FFP 6 REVISED: 10/17/08ab
ADDENDUM 4 REVISED: 8/20/07
REVISED: 2/19/07
REVISED: 1/24/07

6TH FLOOR PLUMBING PLAN
ST. TAMMANY PARISH ADMIN. COMPLEX
520 OLD SPANISH TRAIL
SLIDELL, LOUISIANA

RENOVATE OFFICE BUILDING

P-6

SIXTH FLOOR PLUMBING PLAN
SCALE: 1/8" = 1'-0"

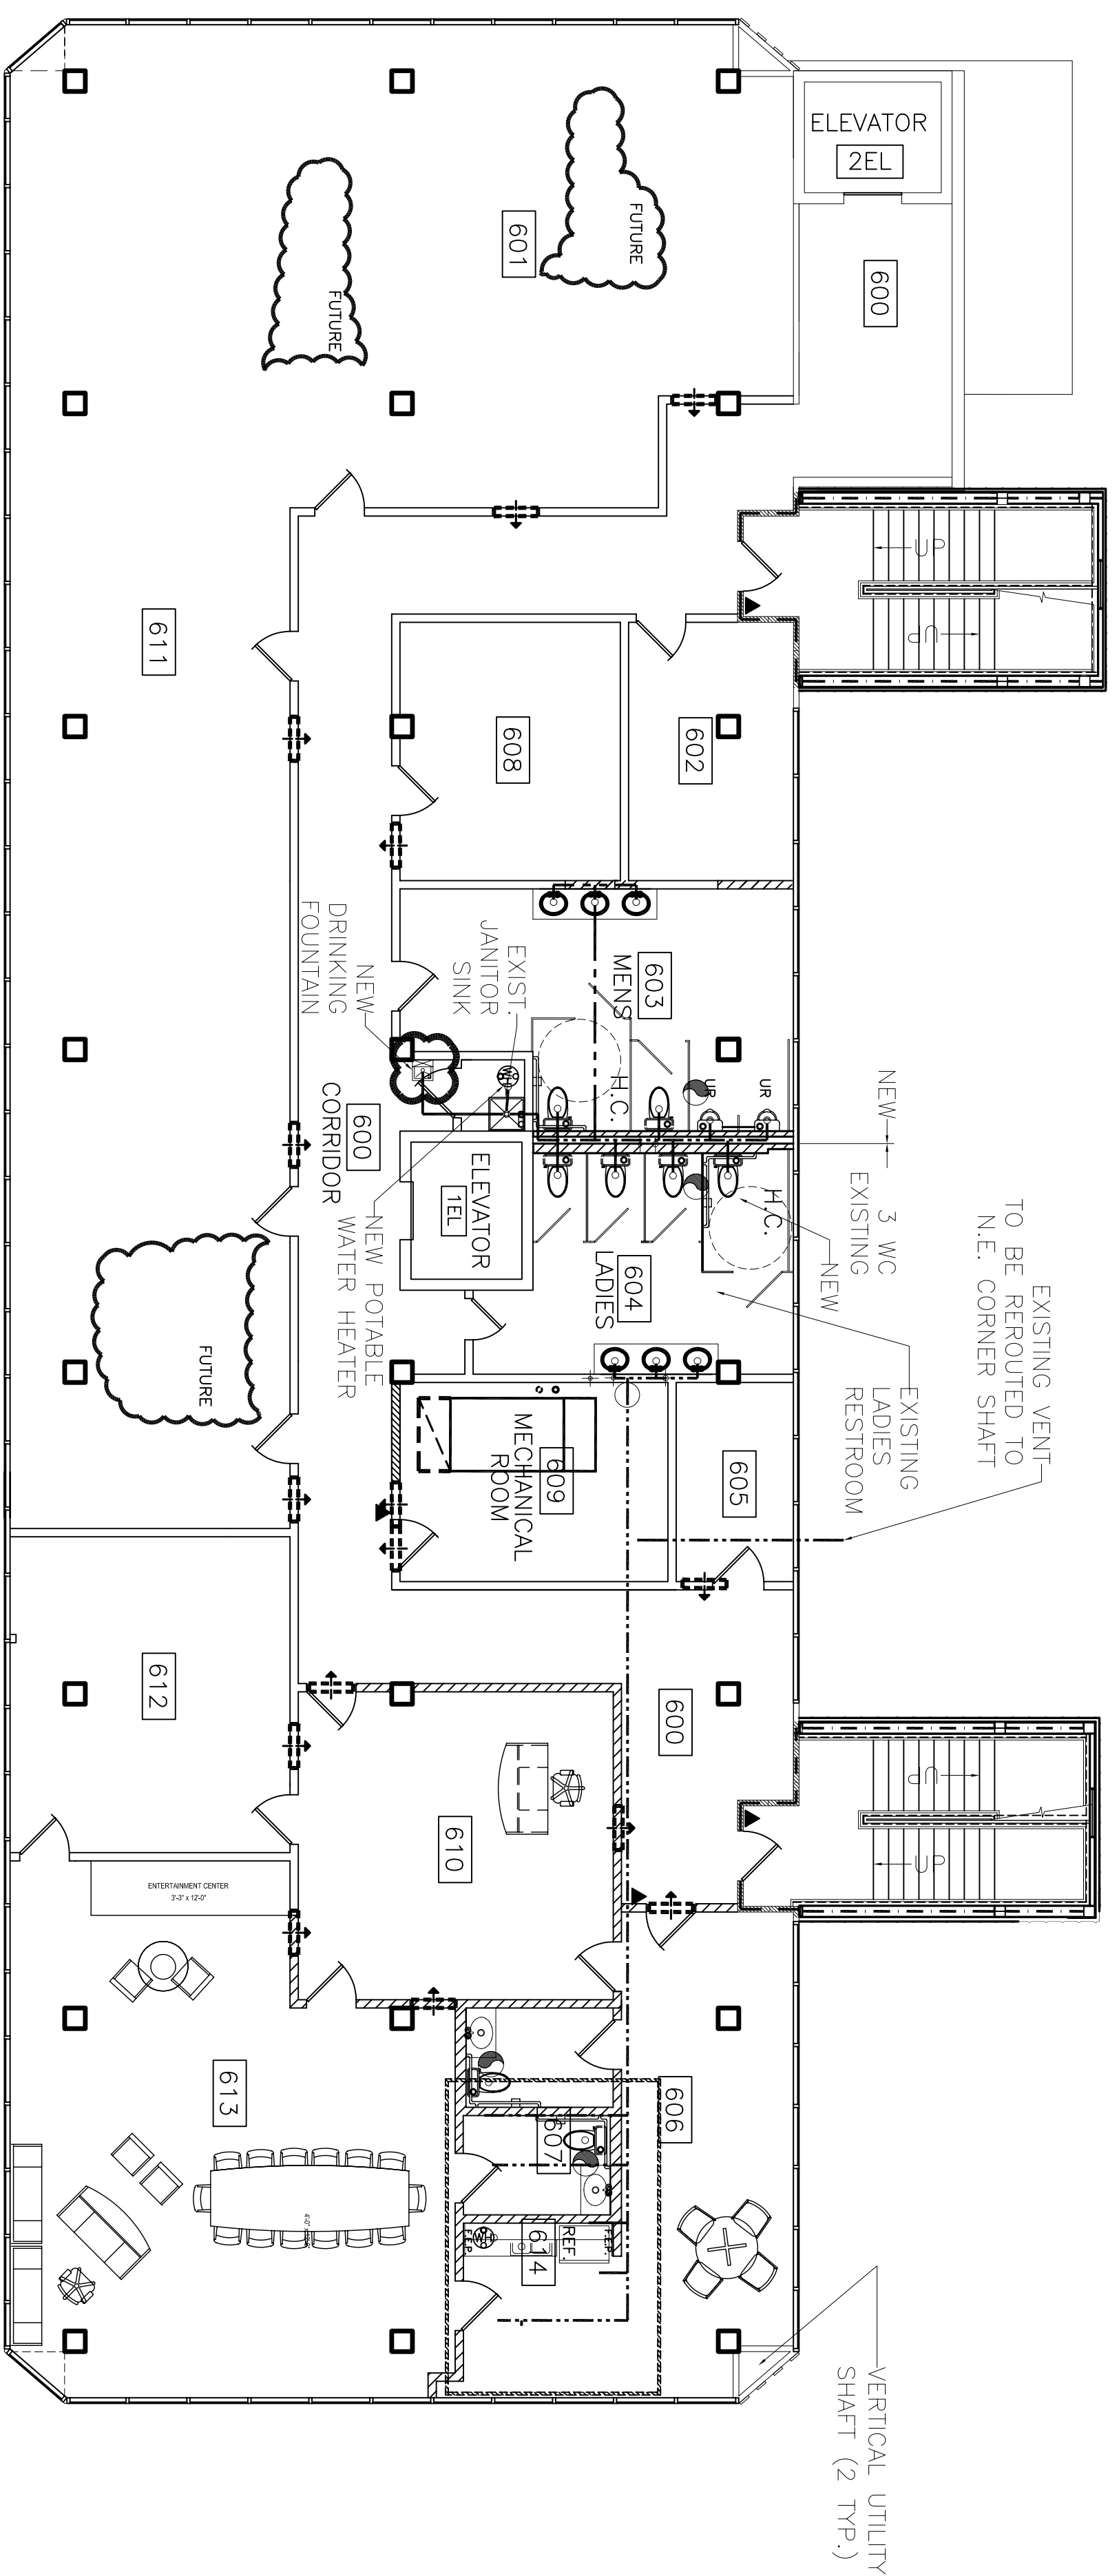
☒ - INDICATES ITEMS CHANGED - 10/17/08
☒ = ADDENDUM 4 CHANGE
